Quality American Motorcycles

TB01-11-01

Technical Bulletin

SEAT PAN INSERT UPDATE KIT - ATV

Fig. 1. Typical ATV seat - bottom view

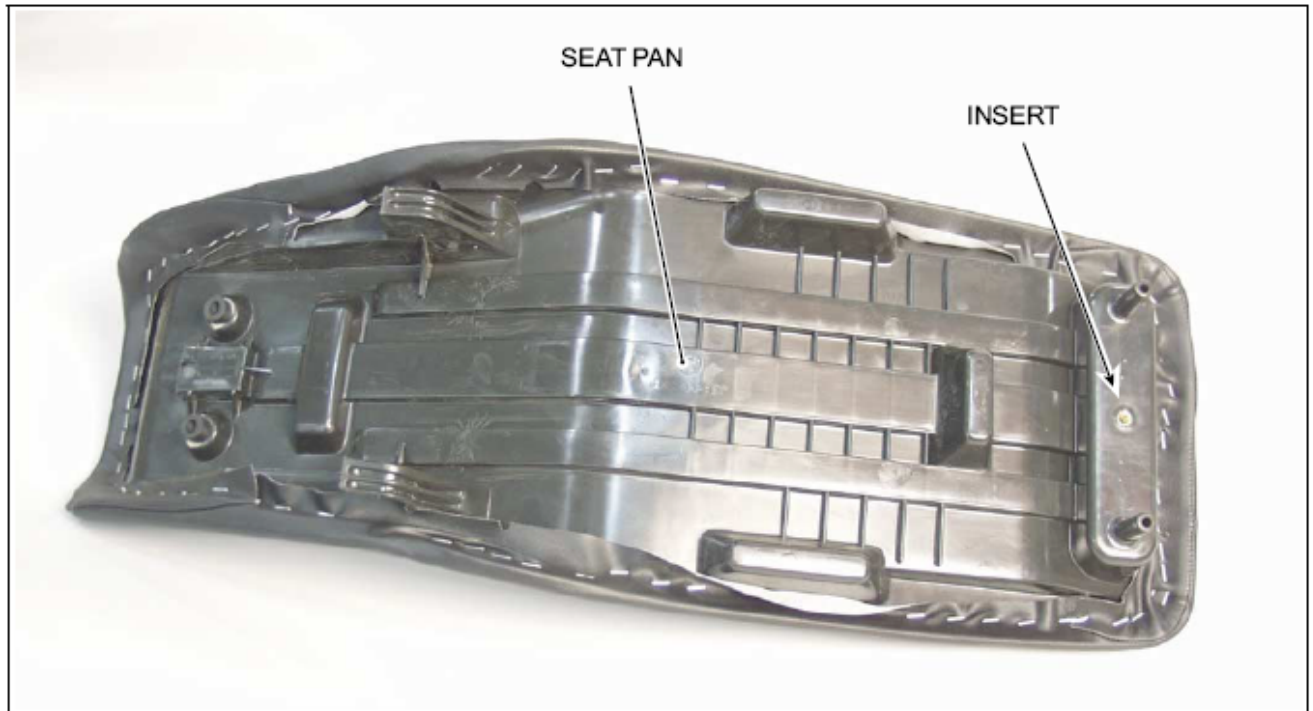
Kit (P/N 913-6000717) is available to repair ATV seat pans installed with the TYPE 1 insert. The replacement insert included with the kit can only be used to repair seats installed with TYPE 1 inserts. The kit can not be used to repair seats installed with the TYPE 2 insert. If a TYPE 2 insert has pulled from the seat, the entire seat must be replaced; no repair kit is available.

The seat pan hole must be undamaged and the hole diameter can not be greater than 10mm. If the seat pan hole is larger than 10mm or damaged, the seat must be replaced with a new one.
